**1260 Republican Street**  
Design Review Proposal Packet

Project Number: 3012256

DRB Date: Dec 15, 2011

Summary of Early Design Guidance

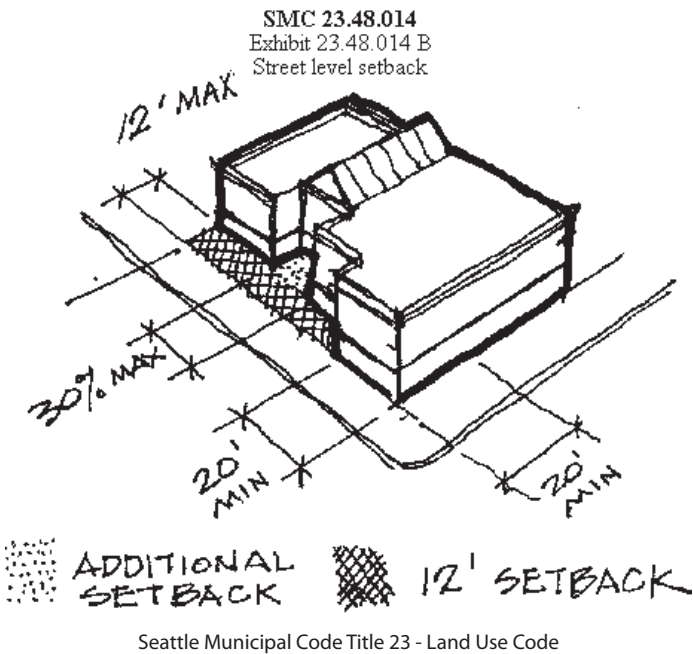
CODE	DEPARTURE REQUEST	RATIONALE
23.48.014 D1	Quantity of Hardscape in Setback	The DRB requested additional plaza space to enhance the pedestrian experience. A significant portion is under cover such that landscape would not fare well, therefore, the design provides additonal landscape at levels 2, 7 and the sloping roof up from Level 7.
23.48.024 A2	Quantity of Hardscape in Setback
